SERVICETEKNOTES

TABLE OF CONTENTS

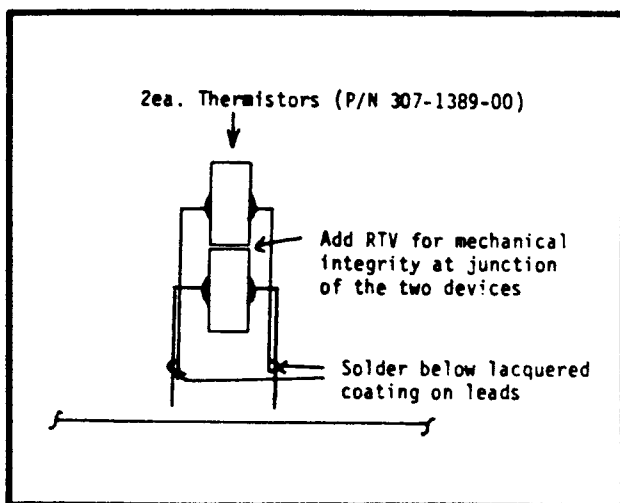
1. Remove the power supply from the display.
2. Remove RT180 and RT181.
3. Connect a 20 ohm resistor from kit between pin 3 of RT180 and pin 3 of RT181.
 - a. Solder resistor leads close to the body of RT180 and RT181. Refer to figure below.

4. Cut circuit run on component side of L.V.P.S., between J7 pin 2 and RT181, next to RT181. Also cut circuit run between RT181 and RT180.
5. Using approximately two inches of wire from kit, on the solder side of the circuit board, solder one end to J7 pin 2 and solder the other end to RT180 pin 3.

FIGURE 2

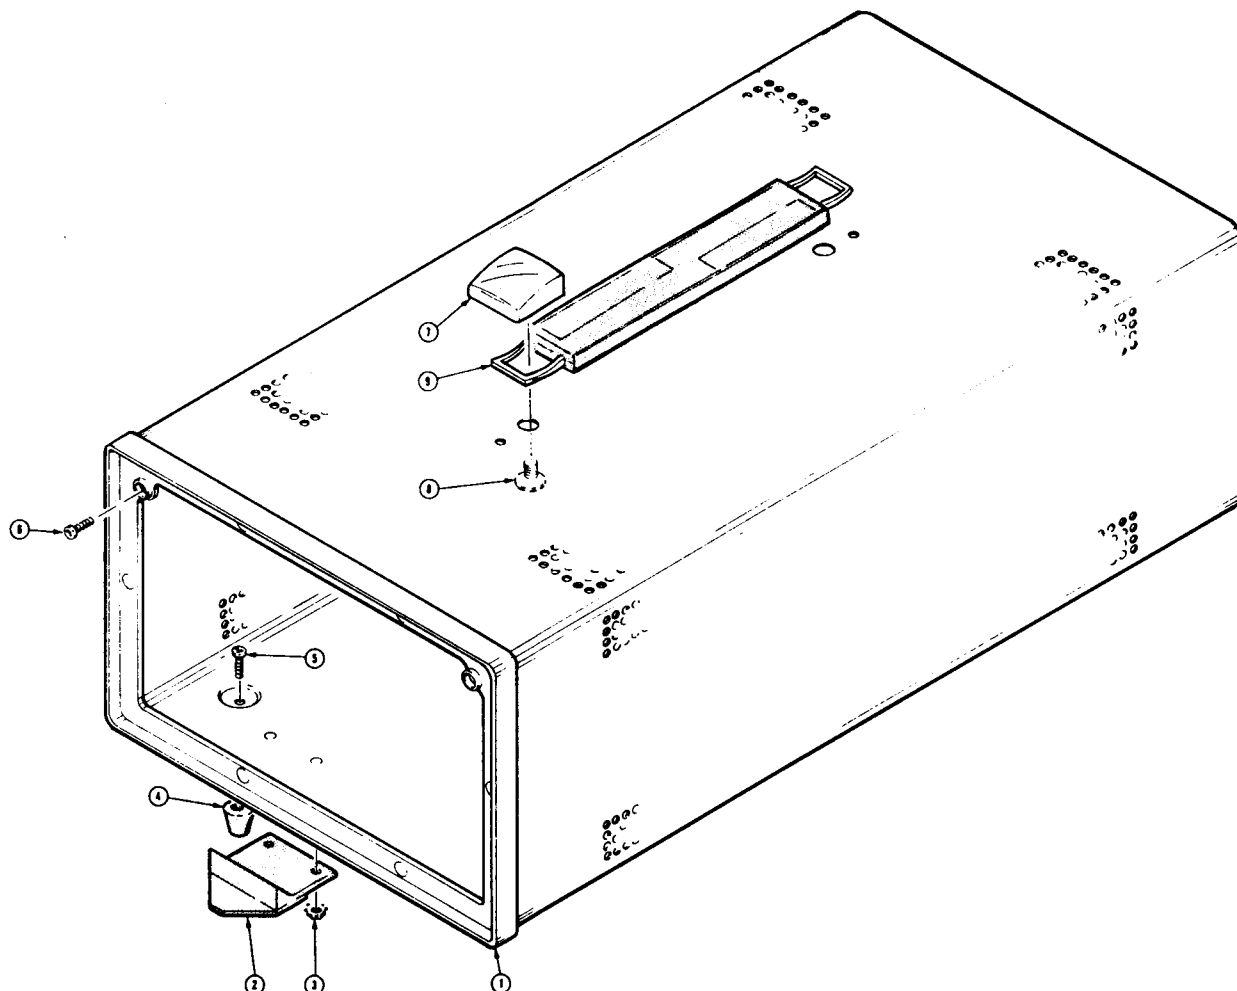
NOTE: Figure 2 is an example of the 1700F02 Cabinet as it was before Mod 54630. The picture is representative of 1700F02's between Mod 54630 and Mod 60091, with exceptions noted below.

FIGURE 3

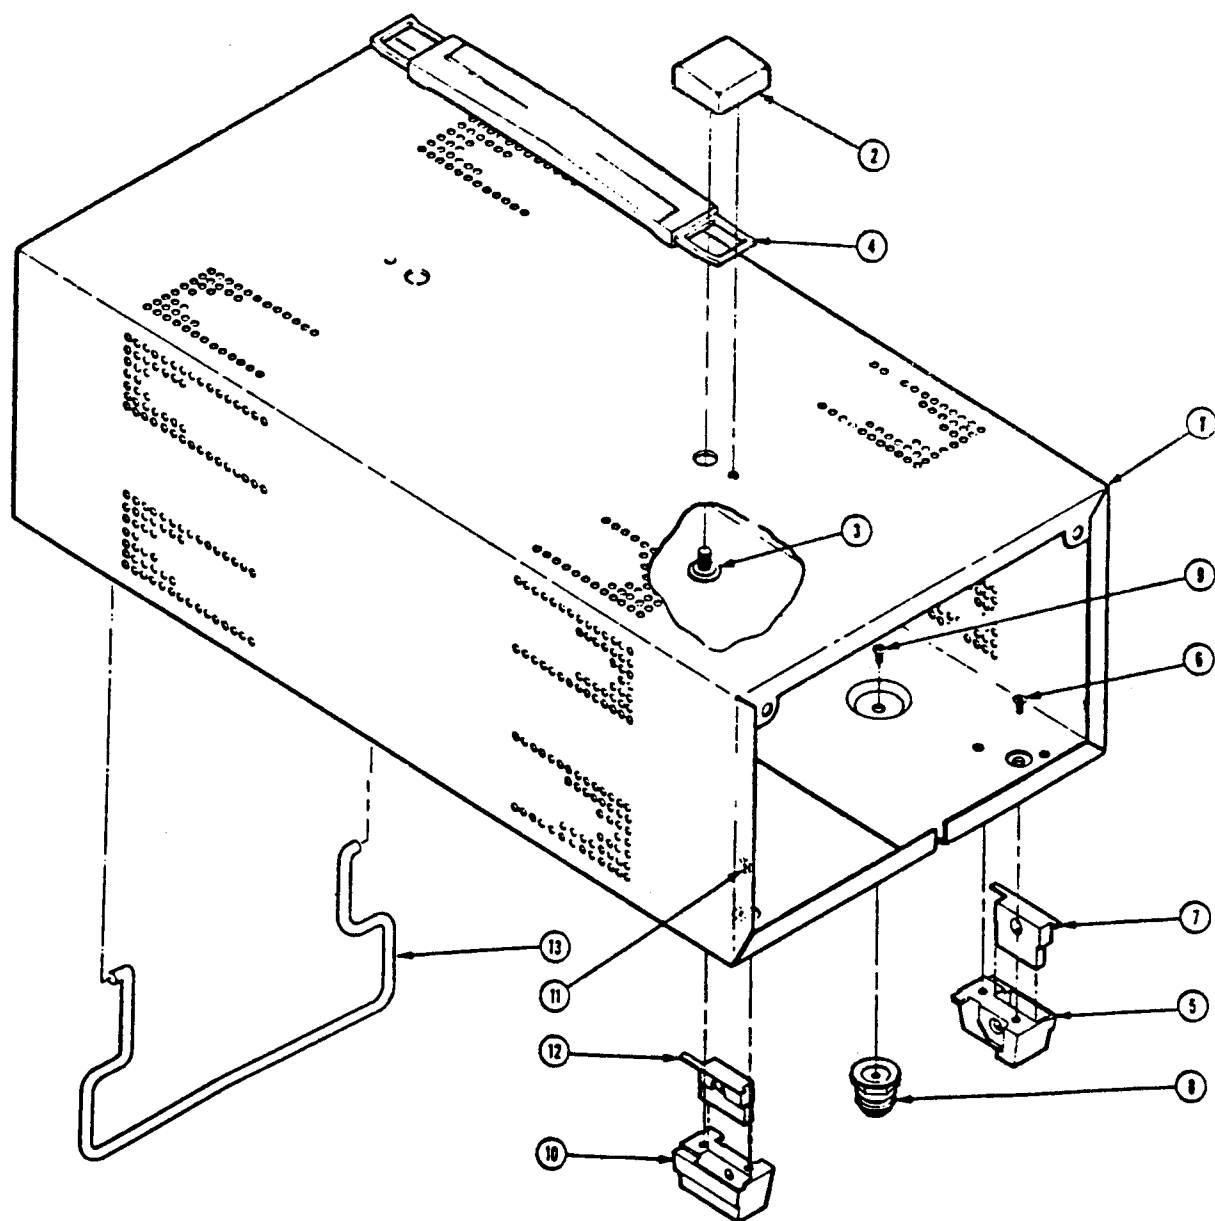
Today's mod (60091) makes substantial changes to the 1700F02, and is illustrated in Figure 3. Parts used on this cabinet before Mod 60091 are still orderable.

A30-Microprocessor circuit board assembly.

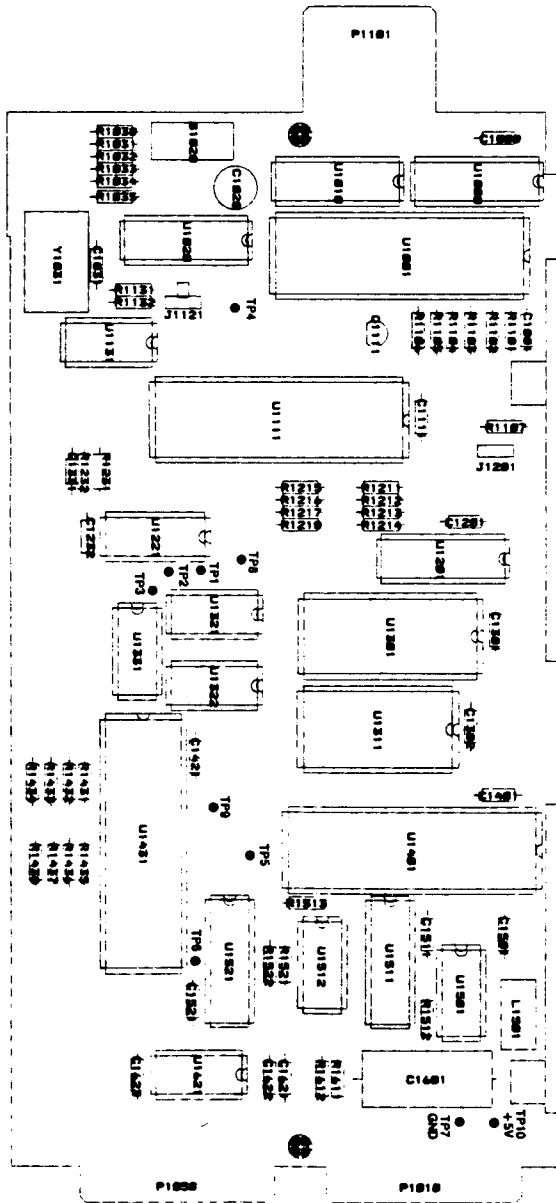
CKT. NO	QTY	PART NO.	DESCRIPTION
REMOVE:			
A30	1EA	670-6907-01	MICROPROCESSOR CIRCUIT BOARD

ADD:			
A30	1EA	*671-0418-00	MICROPROCESSOR CIRCUIT BOARD

ADD:**To Schematic 4 - VERTICAL DEFLECTION AMPLIFIERS:**

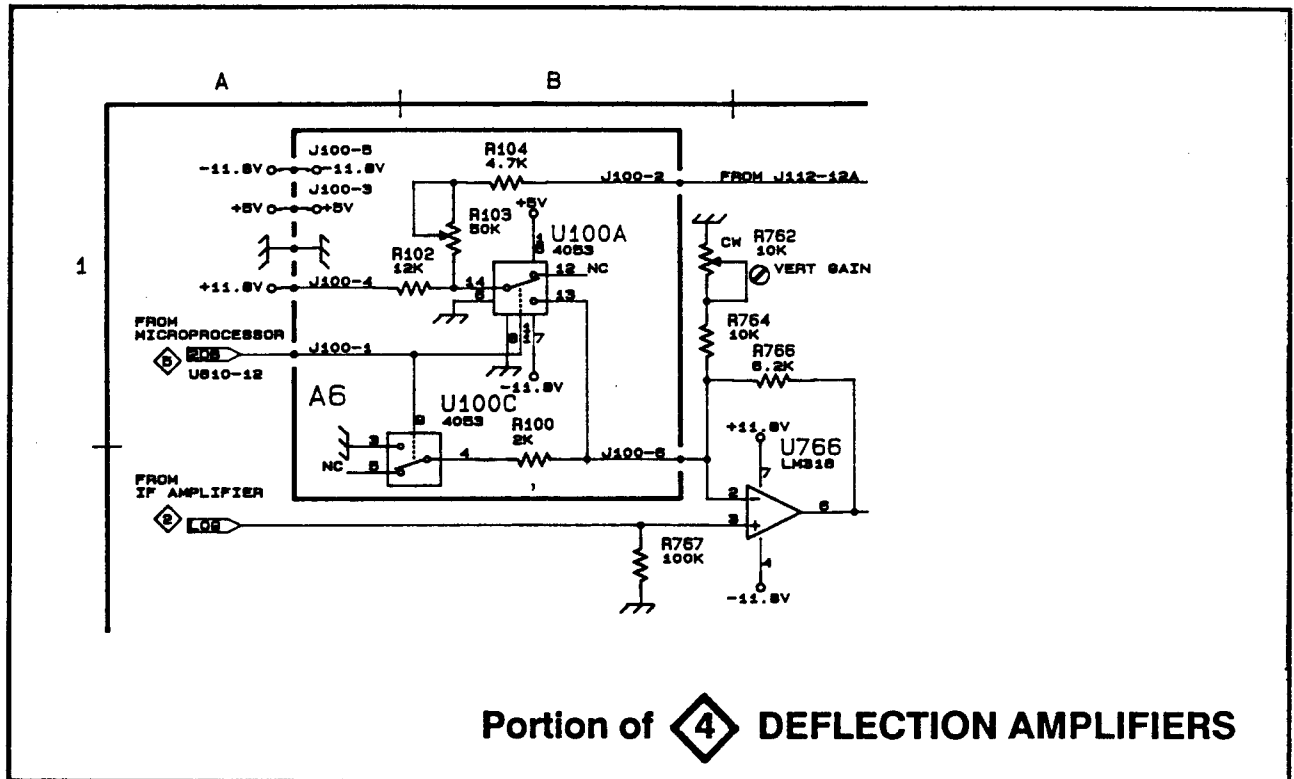
New Circuitry Shown Below

**ADD:****To Schematic 5 - MICROPROCESSOR:**

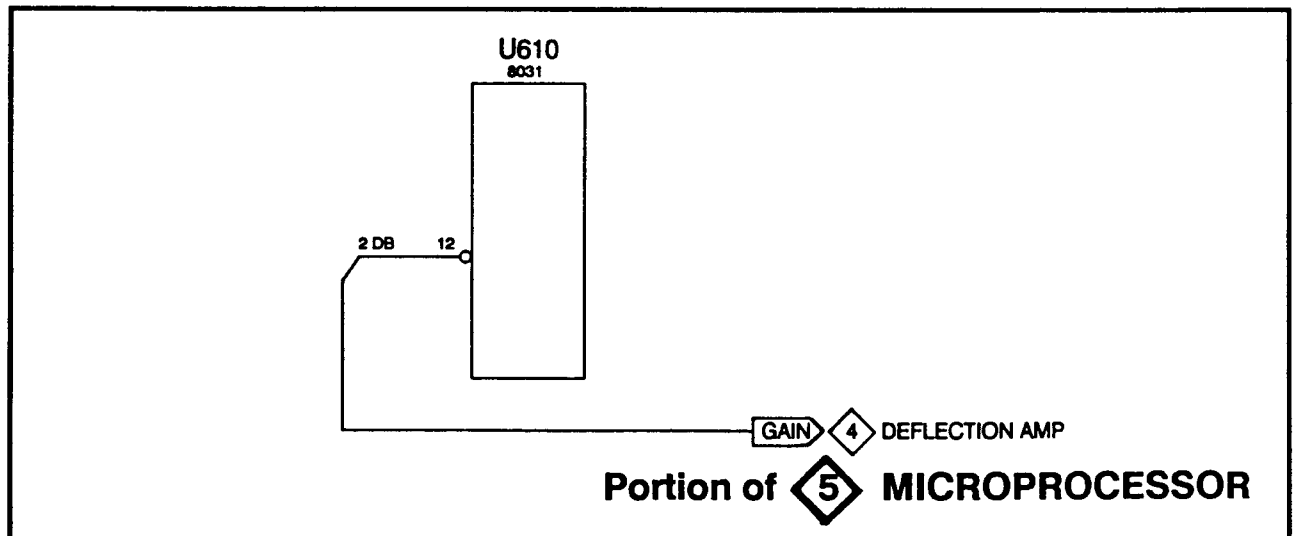
New connection shown below

Fig. 2-1A. 1705 front panel for SN B020000 and Up, showing the location of controls. Circled numerals relate to the accompanying control function descriptions.

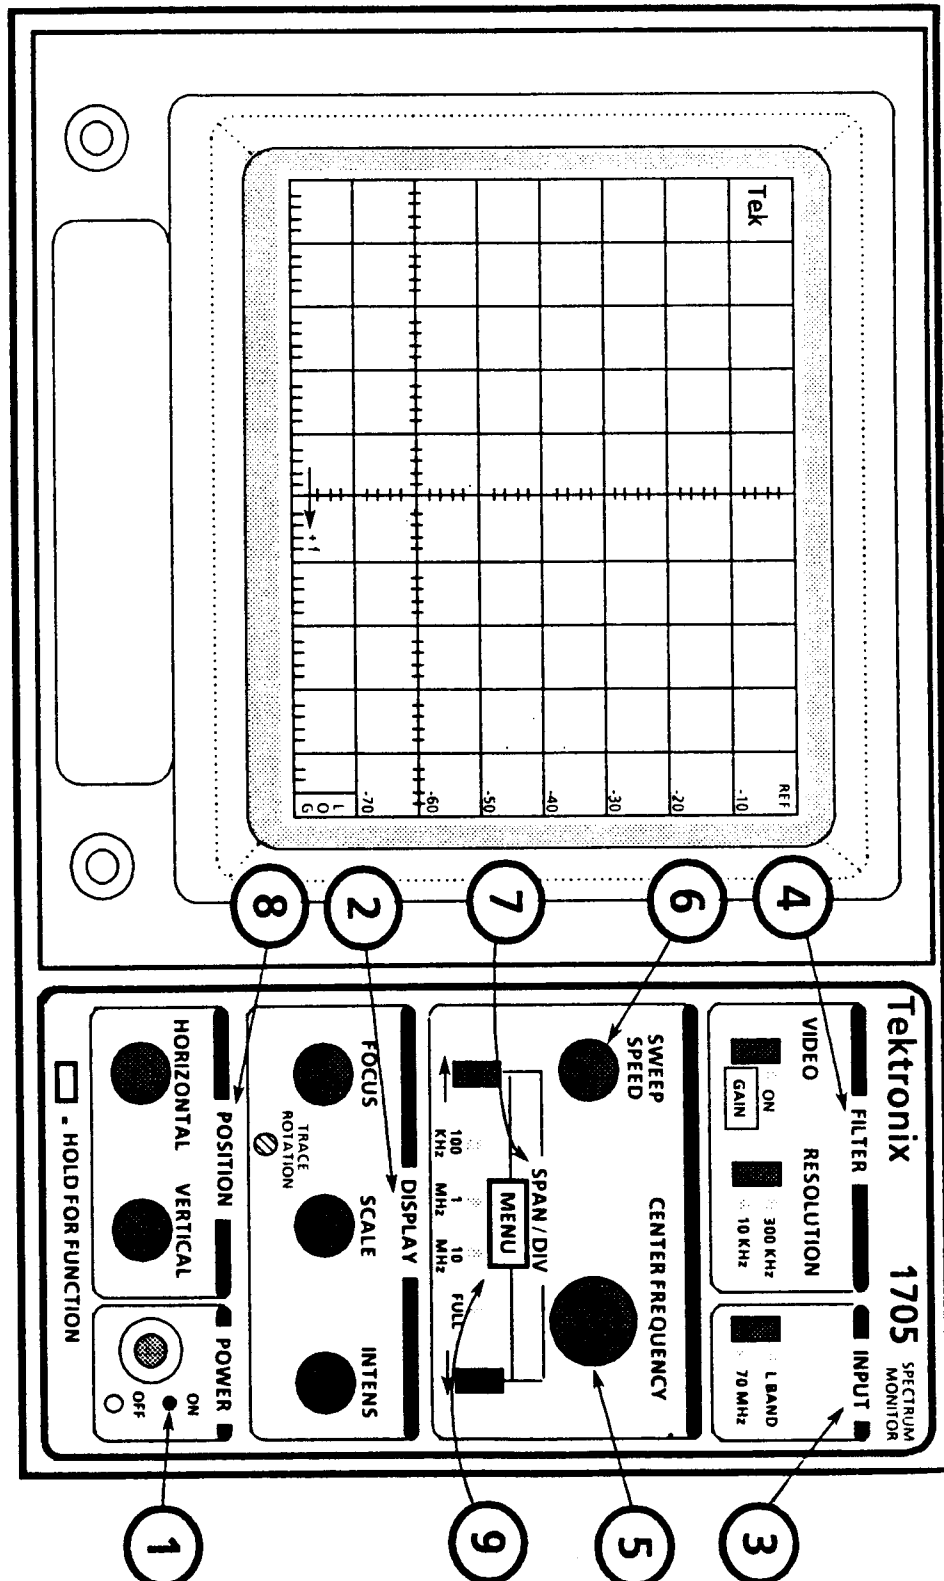
ADD: Sect. 2, Page 2-3, Fig. 2-1A

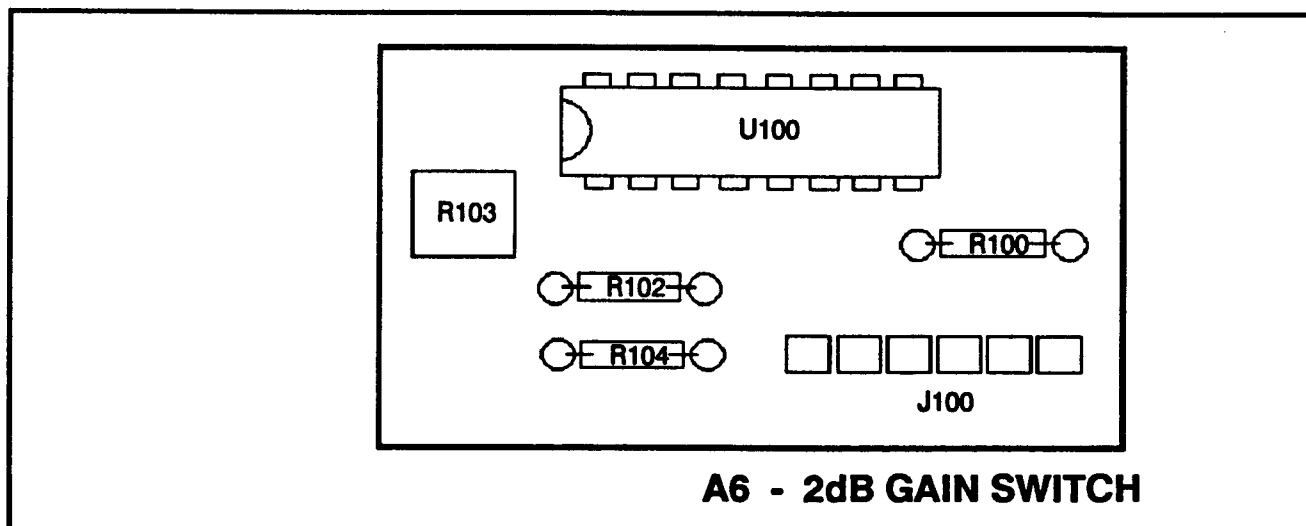
New Circuit Board Illustration Shown Below
